SJRWMD and SWFWMD Responses to Stakeholder Comments on the Draft Central Springs Groundwater Flow Model (CSM) version 1.0

January 31, 2024

APPENDIX C

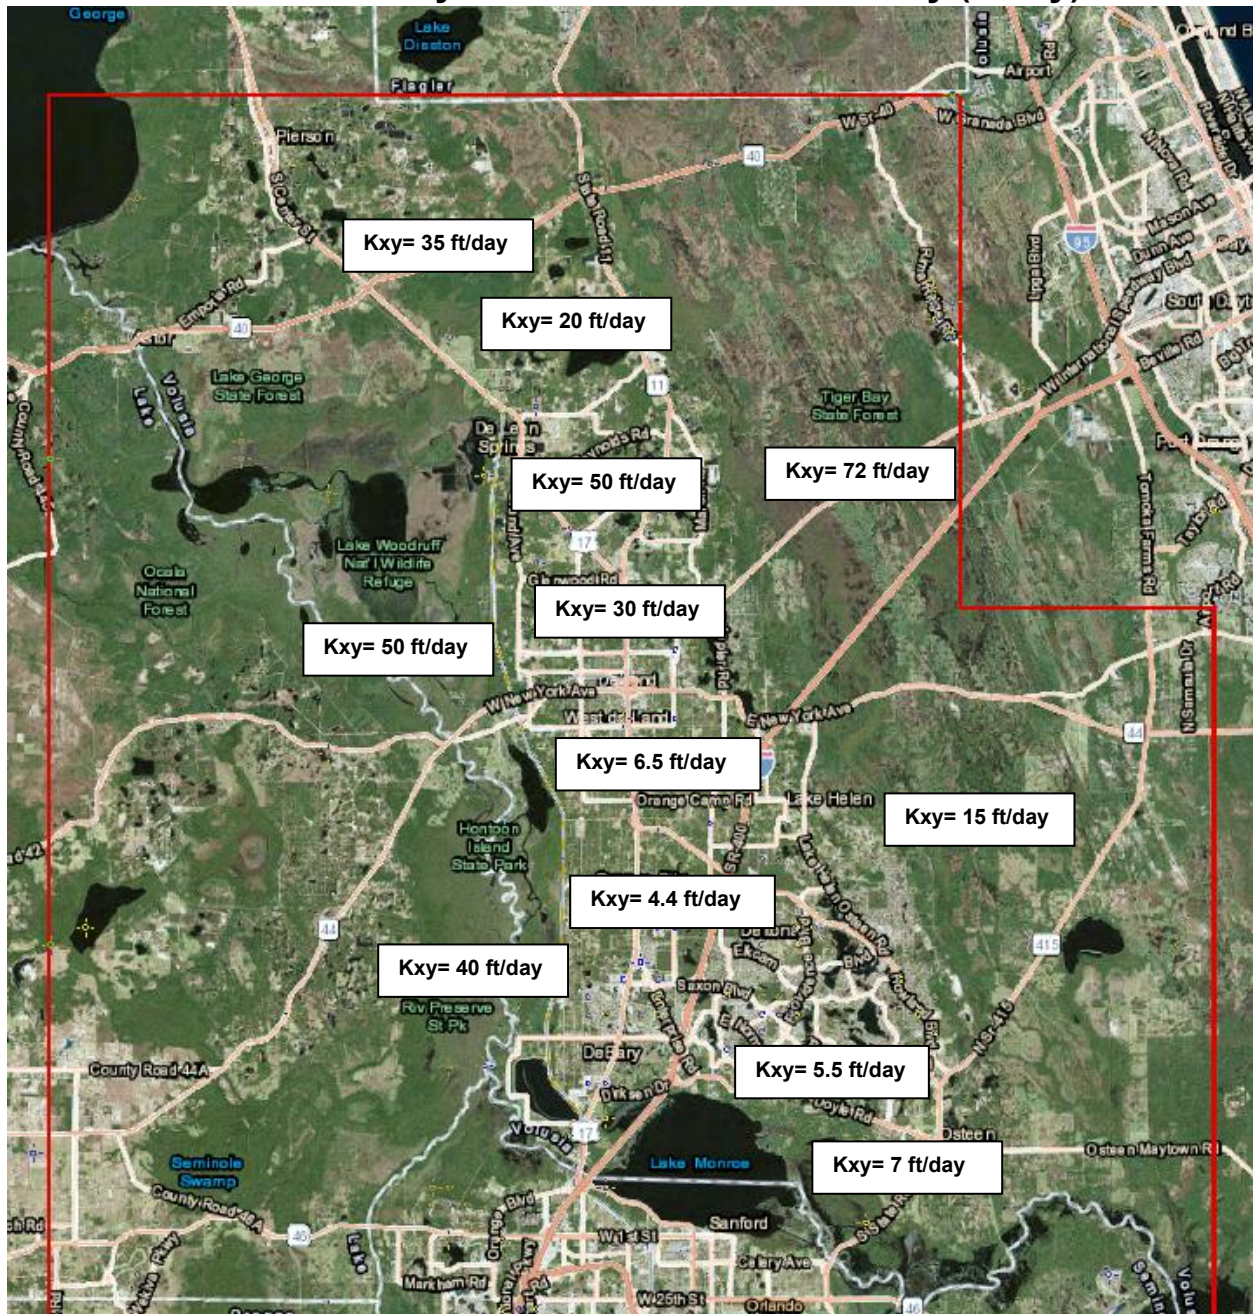
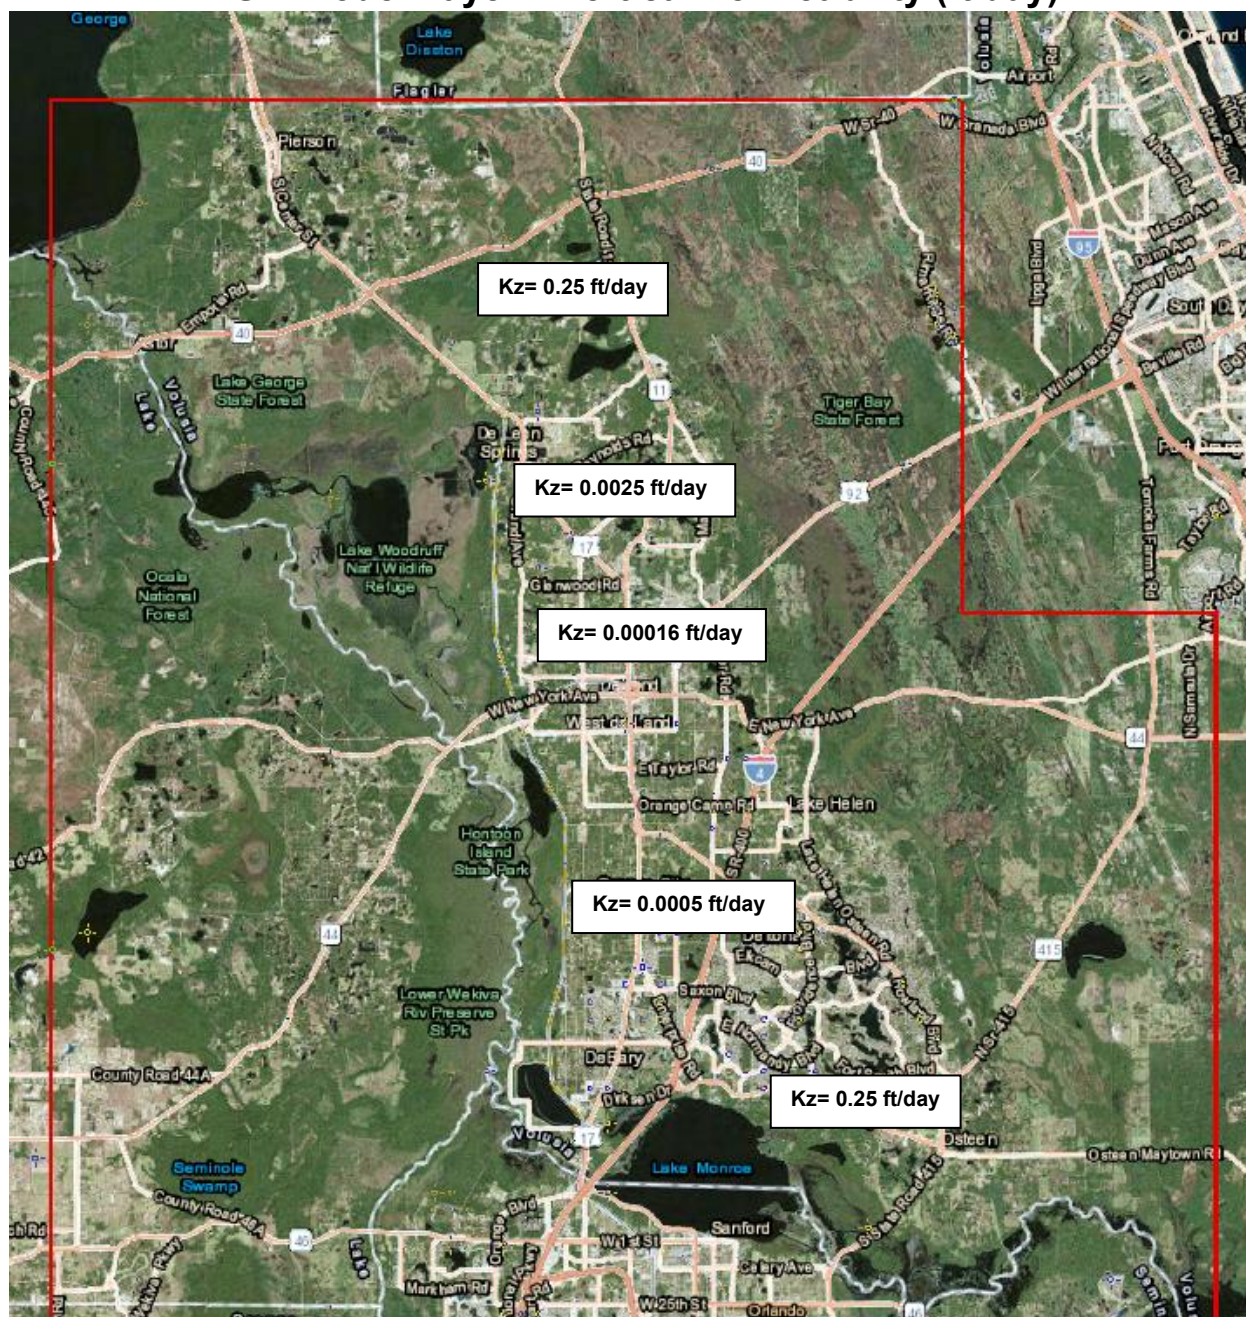
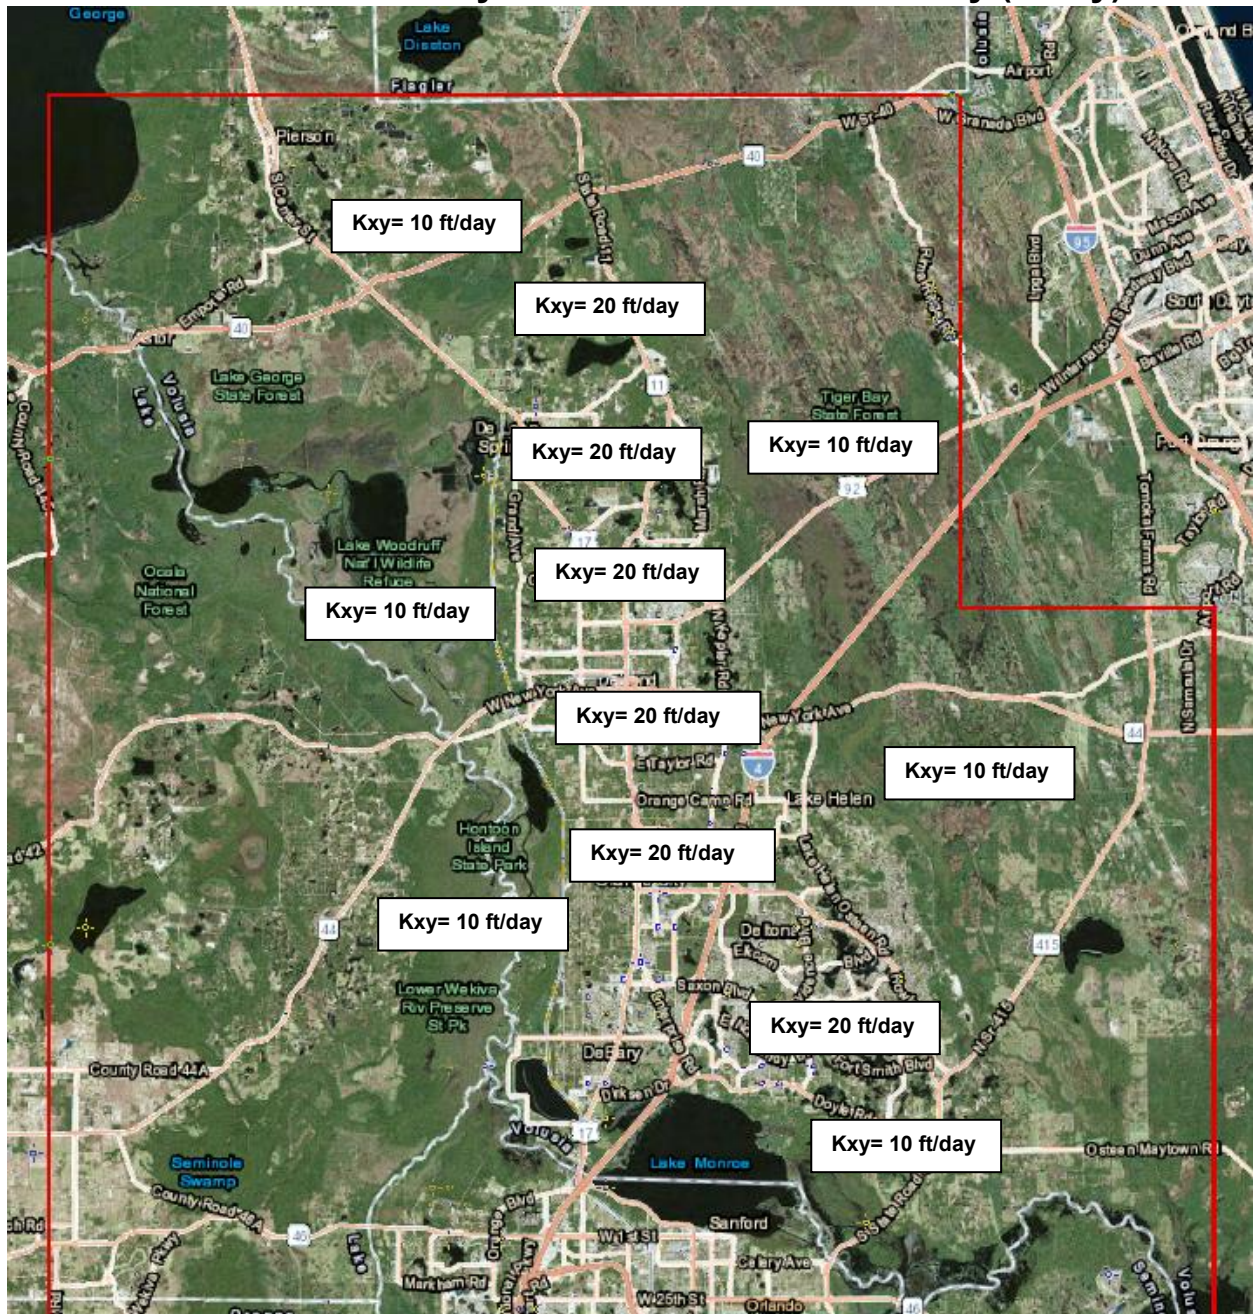
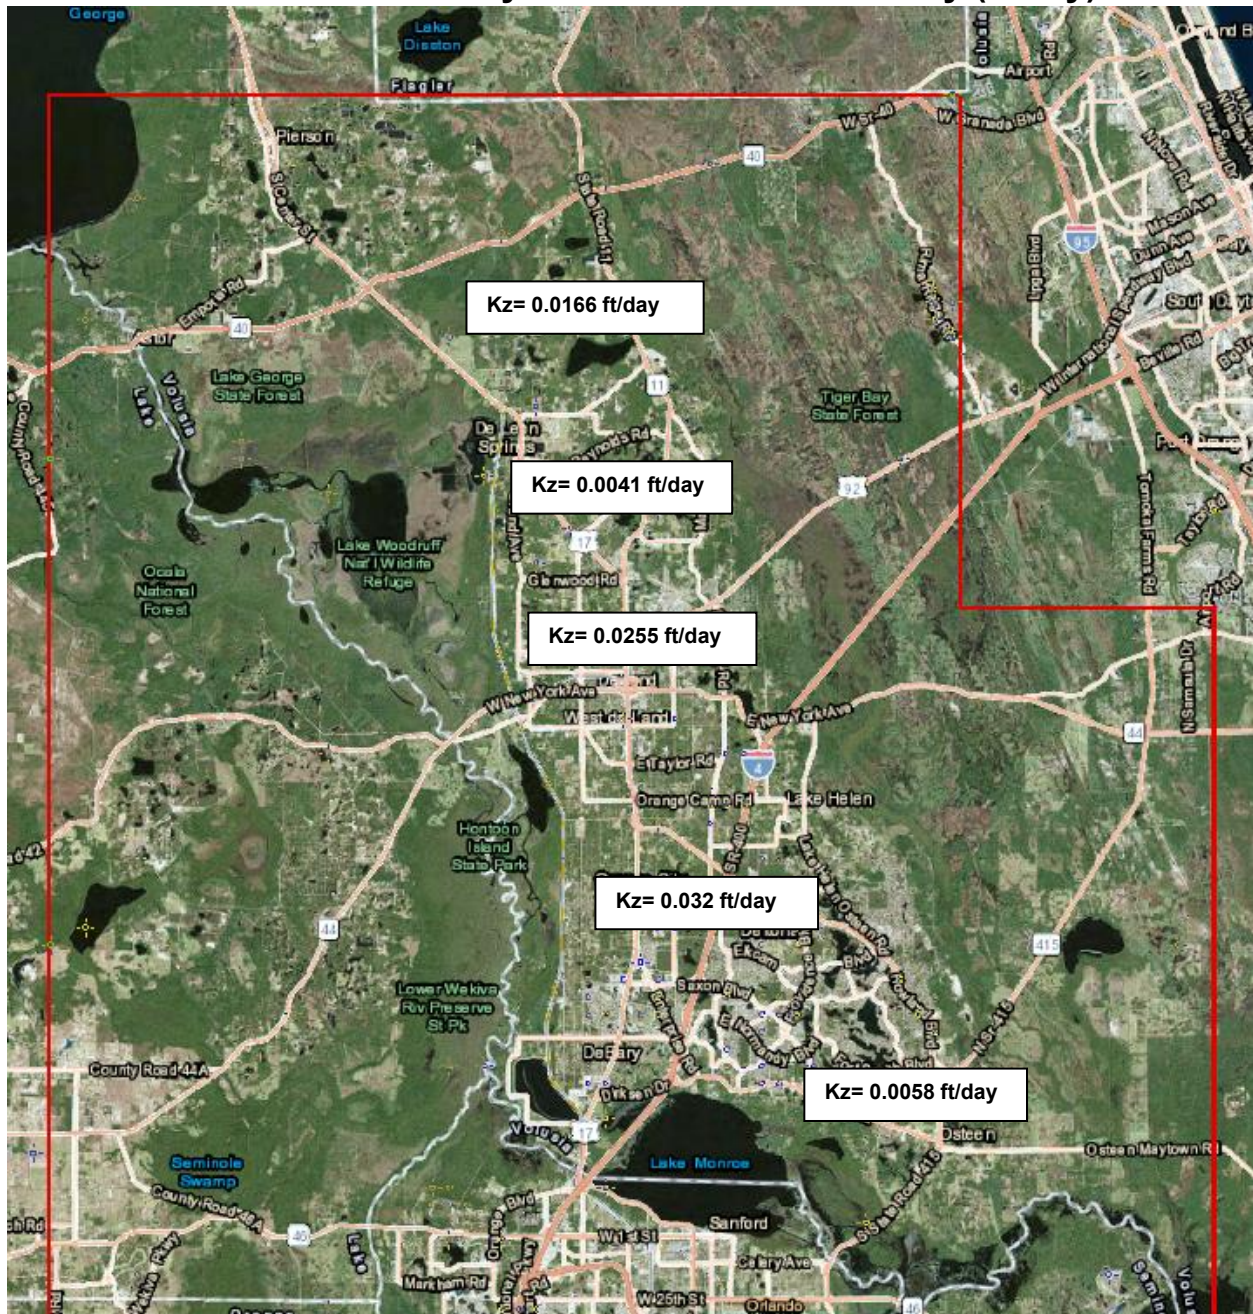
Comment #6: *Review of the permeability values reveals a calibration concern in terms of the variation of the values in the CSM model. Where the horizontal permeability values are expected to be lower, i.e., low and wet areas, the values are high and where the values are expected to be higher, i.e., high and dry ridge areas, the values are very low [see Appendix C of the WVWS/AEI report].*

Additional model parameters reviewed and compared include the horizontal and vertical permeabilities of the surficial aquifer. Based on the CSM model response to recharge it appears that the vertical permeability (leakance) between the surficial aquifer and the UFA may be poorly calibrated. The comparative water balance analyses presented above have already indicated the possibility of this problem. For this purpose, we have extracted permeability values from the surficial aquifer of both models at selected points across the west Volusia ridge and the resulting maps with superimposed horizontal and vertical permeability values are included in **Appendix C**.

Response: As part of the CSM v1.1 modeling effort, the Districts will be re-evaluating the aquifer parameters in this region.

Figure 1. Simulated ICU K_V in CSM and Volusia Model.

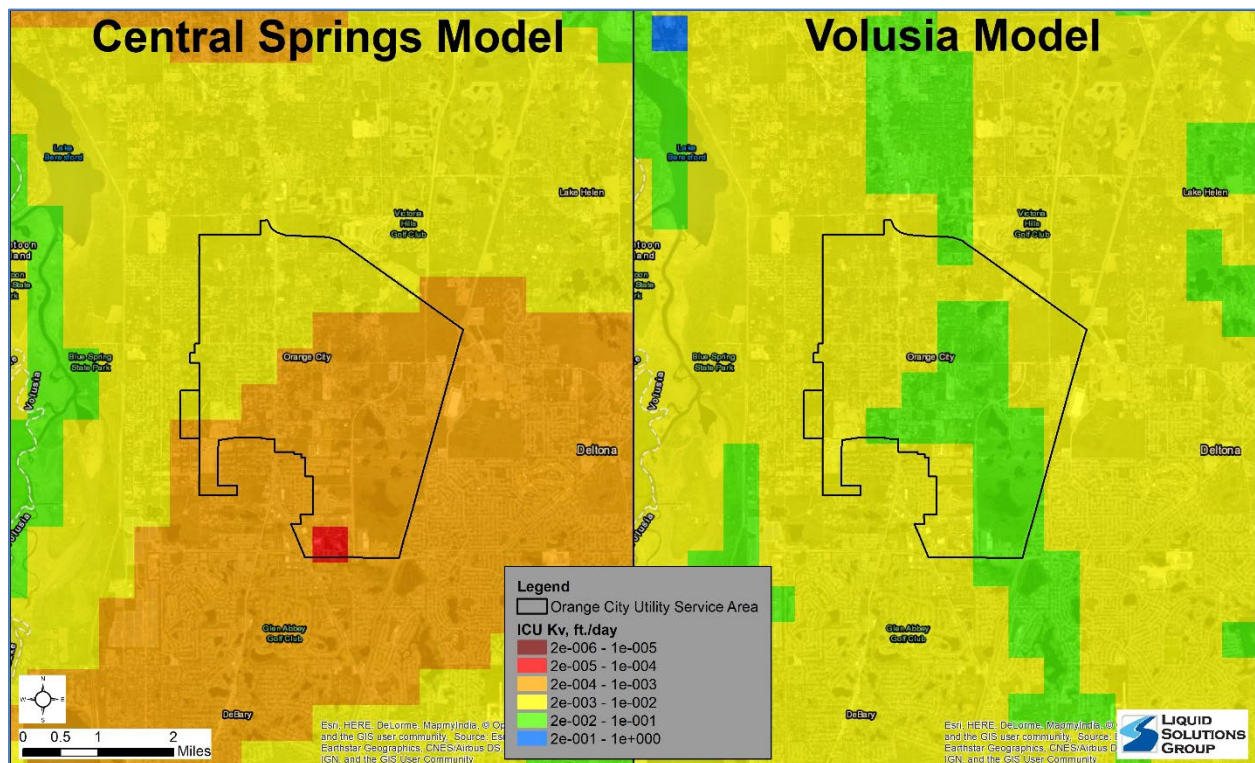
1. The simulated vertical hydraulic conductivity (K_V) of the Intermediate Confining Unit (ICU) (CSM’s Layer 2), within and in the vicinity of the City’s utility service area, is remarkably low. For example, the CSM ICU K_V is up to 100 times lower than the simulated ICU K_V in SJRWMD’s Volusia Groundwater Flow Model (a.k.a., Volusia Model), the existing official groundwater flow model used by the SJRWMD for regulatory purposes in the Volusia County region (See **Figure 1**). Furthermore, the CSM ICU K_V is also up to 100 times lower than the simulated ICU K_V in the Transient West Volusia Groundwater Model (TWVGWM), an existing locally refined and calibrated model developed for and used by the West Volusia Water Suppliers (WVS) utilities, and accepted by the SJRWMD as a tool for CUP evaluation purposes, herein referred as the “WVWS Model” (see **Figure 2**).

Response: The Districts will be re-evaluating the aquifer parameters and drain cell usage in this region and may recalibrate the model as part of the CSM v1.1 modeling effort.

Figure 3. Aquifer Recharge Potential and Hydrogeologic Characteristics near the City.

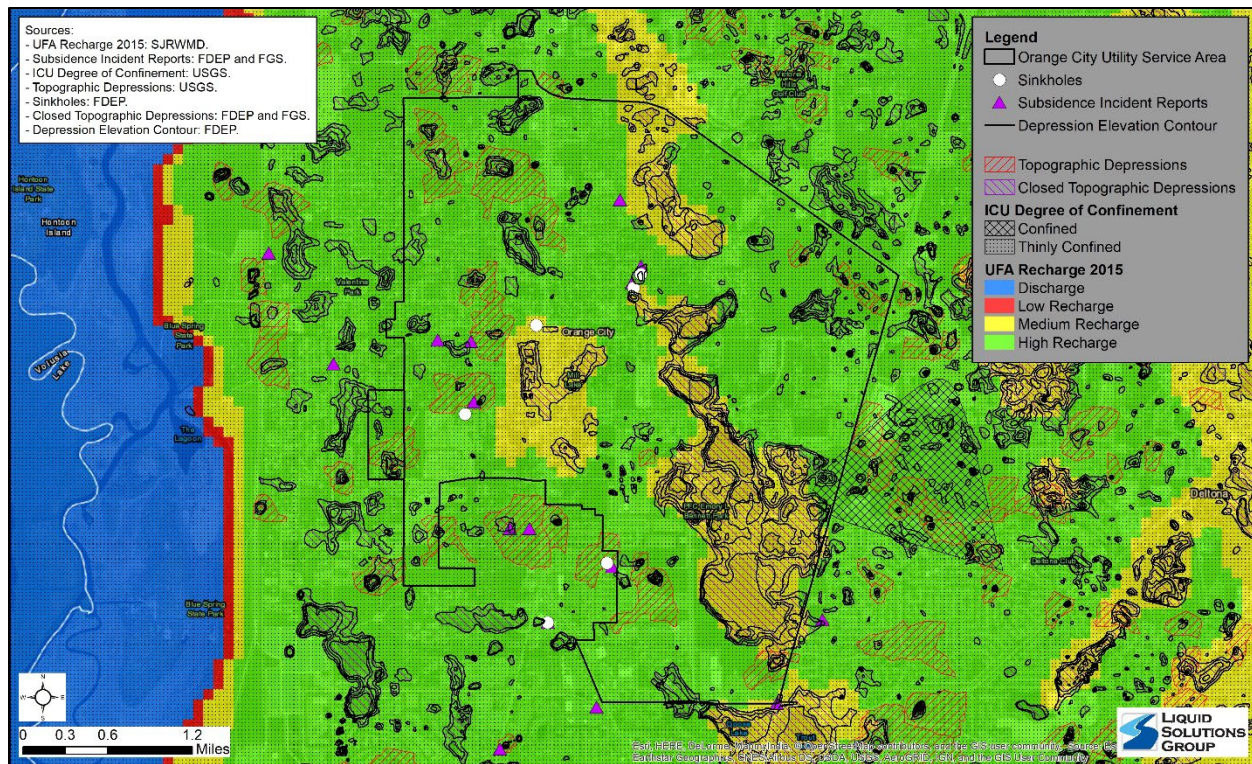
As shown in **Figure 3**, the area near the City has been defined by the SJRWMD as a zone of medium (moderate) to high recharge in its vector digital data titled "UFA Groundwater Recharge (2015)".

As shown in **Figure 3**, the City is located in a region characterized by numerous sinkholes, and closed topographic depressions. Furthermore, the USGS describes the ICU degree of confinement within and around the City as “Thinly Confined” (Williams and Dixon, 2015). These hydrogeologic features and descriptions match the characteristics described by Boniol and Mouyard (2016) for areas with high to moderate UFA recharge potential.

Figure 5. CSM’s Drain Cells near the City.

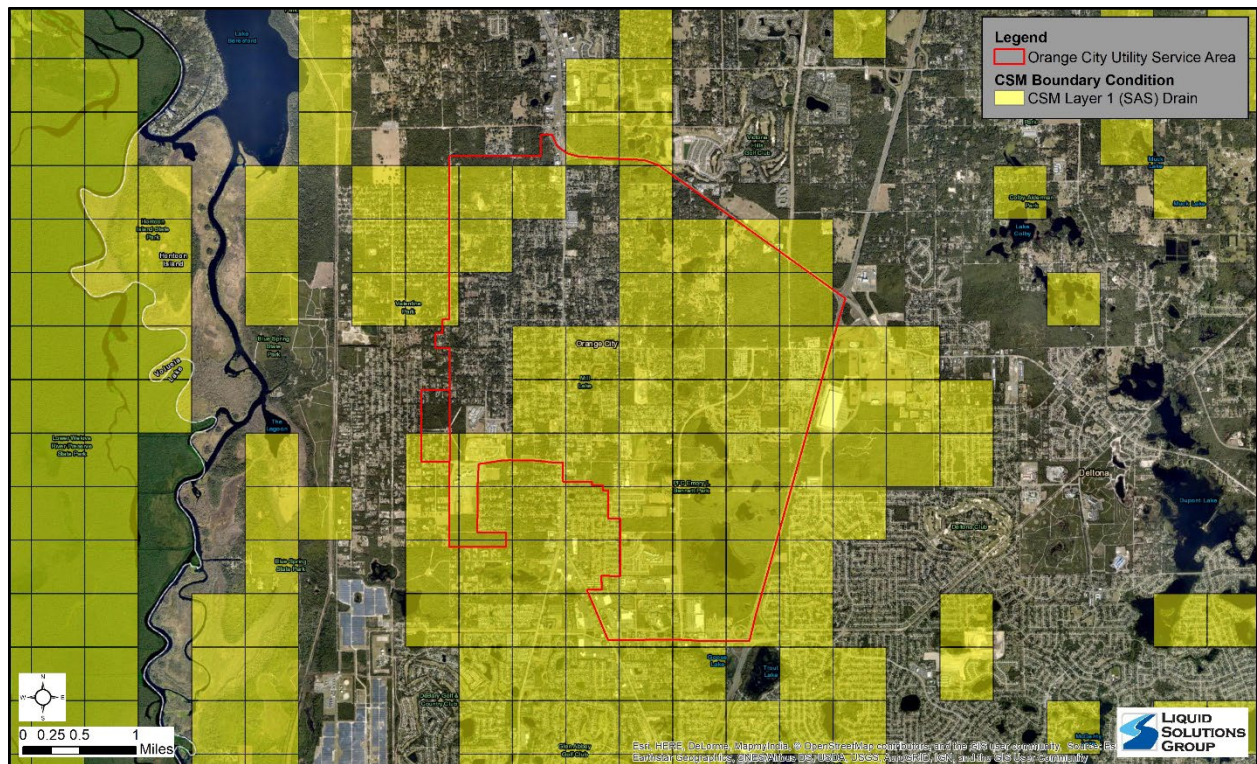
2. The simulation of wetlands, streams, and/or small lakes within the City, using drain cells appears inappropriate. As shown in **Figure 5**, almost the entire City's utility service area is covered with drain cells in the CSM Layer 1 (SAS). These cells remove simulated excess water in the SAS, when available. However, as described previously, the City is located in a region of moderate to high recharge with numerous closed topographic depressions, sinkholes, and thin confinement (see **Figure 3**).

Response: Use of the Drain Return Package (DRT) requires specification of a return flow fraction of the simulated drain flow, which is difficult to estimate on a regional scale. The model development team agrees that it may not be conceptually appropriate to assign drain cells to certain physiographic areas,
